**RE: NCBC Ch 11 Accessible Dwelling Units and Accessible Routes
2018 NCBC Sections 1107.6.2.2 and 1104**

We would like to request in writing a formal interpretation of the code for the project at 57 Roberts St., Asheville, NC 28801.

Engelhardt/Tom
 Mix-Use Building
 Residence & Gallery
 57 Roberts St.
 Asheville, NC 28801

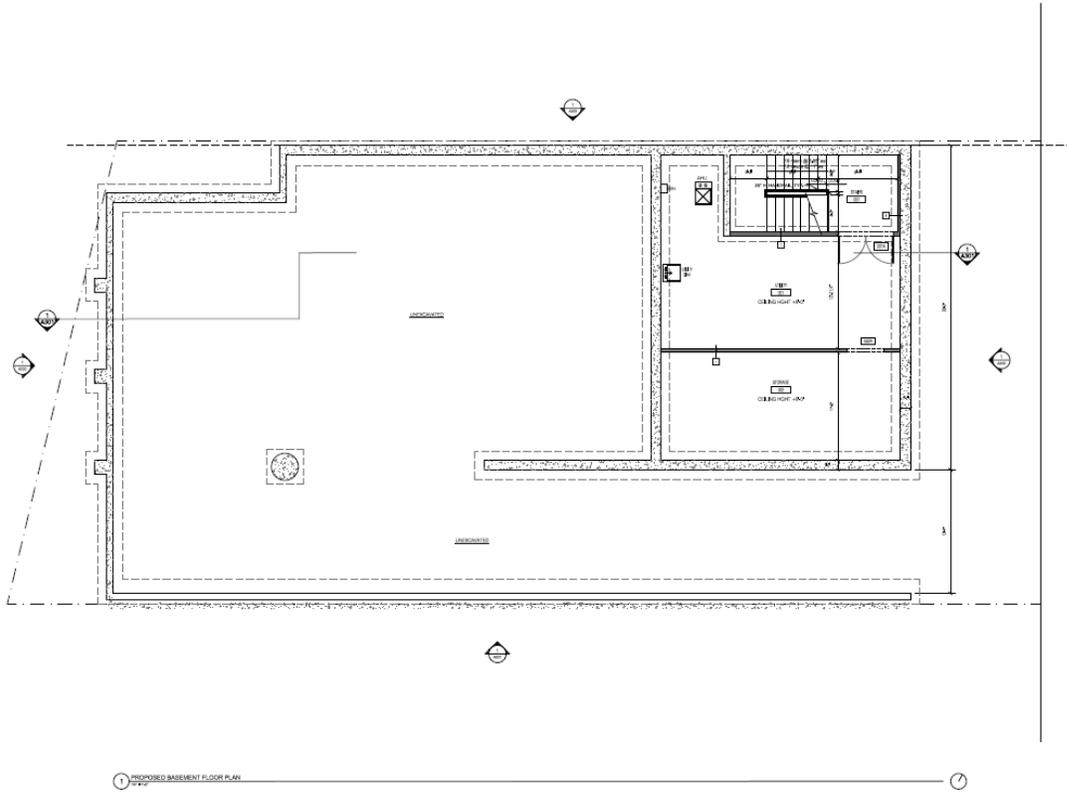
1. Per 2018 NC Building Code, section 1107.6.2.2, Group R-2 occupancies are required to have Type-B units "where there are four or more dwelling units". Since, there are only 3 units in our design we should not be required to provide Type A or Type B units. Is this correct?
2. If correct, and per Section 1104, we should not be required to provide an accessible route to the apartments outside of the vehicular way. Is this correct?
3. For the gallery at ground level, we provided (1) accessible door entrance directly from accessible parking space at the rear of the building. Is this acceptable as the accessible route from parking?

The NC Codes do not require the proposed dwelling units to be Type A or Type B units.

The code does not require an accessible route to the proposed dwelling units.

Yes. The NC Codes do not require the proposed vehicle parking to be connected to any building entrance other than the building entrance closest to the parking. There is also no code that prevents the accessible access aisle from being in the normal pedestrian path of travel for other vehicle parking spaces or in the path of egress from a building.

Proposed
 Basement
 Floor Plan

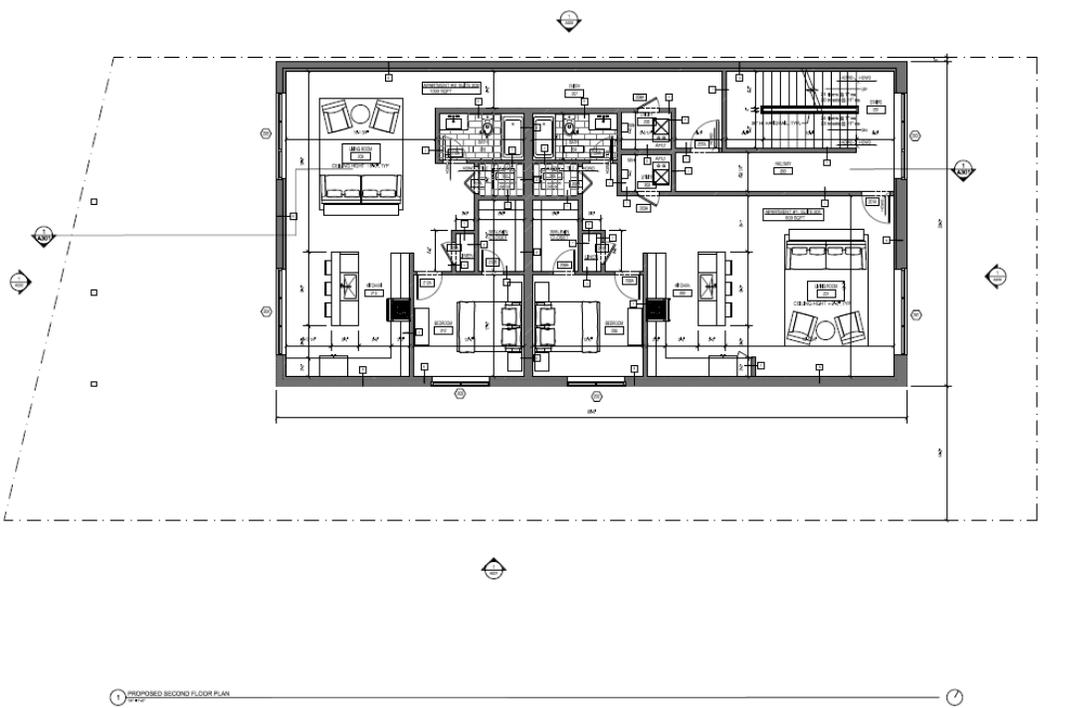
- 1) Per 2018 NC Building Code, section 1107.6.2.2, Group R-2 occupancies are required to have Type-B units "where there are four or more dwelling units". Since, there are only 3 units in our design we should not be required to provide Type A or type B units. Is this correct?
- 2) If correct, and per Section 1104, we should not be required to provide an accessible route to the apartments outside of the vehicular way. Is this correct?
- 3) For the gallery at ground level, we provided (1) accessible door entrance directly from accessible parking space at the rear of the building. Is this acceptable as the accessible route from parking?

Section 1104.3 requires all spaces to be connected with an accessible route. Exception #1 exempts stories that are exempted by 1104.4. The 1st floor is accessible; so, all spaces on that floor are required to be on an accessible route. 1104.3 does not require the parking to connect to all accessible entrances on the first floor.

Section 1106.6 requires accessible parking to be connect to the closest accessible building entrance. It does not require the parking to connect to "all" accessible building entrances. Because Section 1104.5 requires the accessible route to coincide with general circulation paths, the building entrance adjacent to the parking must be accessible to any and all occupants of the automobiles parked in the garage area in order to qualify as the required accessible entrance.
